Structural Review of Masterplan Proposals

Duncannon Fort
July 2023

4 Soldier's Recreational Hall

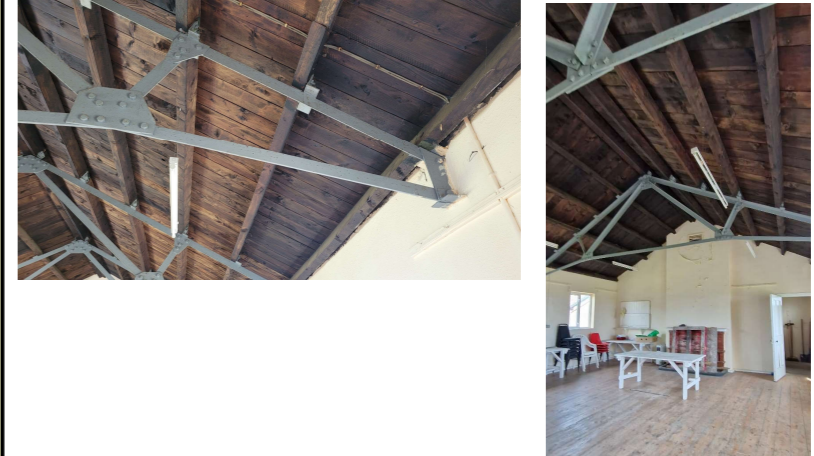
Fair
Roof structure appears in fair condition, repainting of steel trusses required.
Timber floor sub-structure condition unknown, likely full overhaul required.
Opening-up works to the existing floor will help determine capacity.
Localised cracks in render to be repaired.

Unknown loading capacity, assume repairs/replacement required to floor to achieve public loading (5 kN/m2).

Public Building.
Likely that strengthening works will be required to floor, or a full new floor structure will be required.

- 34 Casement Battery**
Rubble masonry walls overlooking beach cliffs

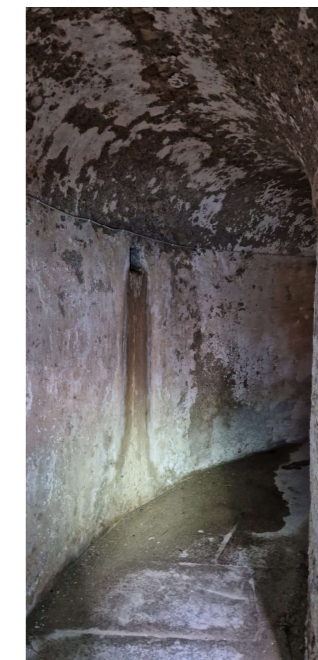
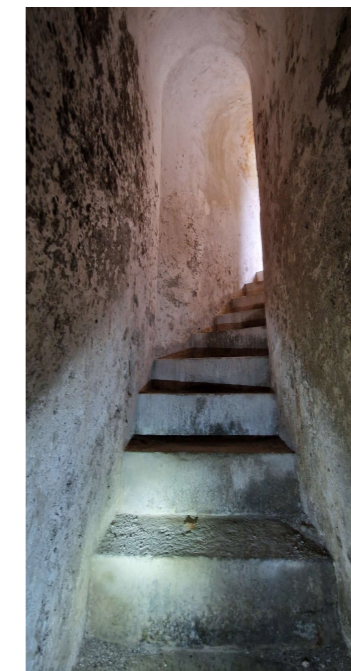
Fair
Some mortar washout and vegetation growth
Localised repairs required to masonry only
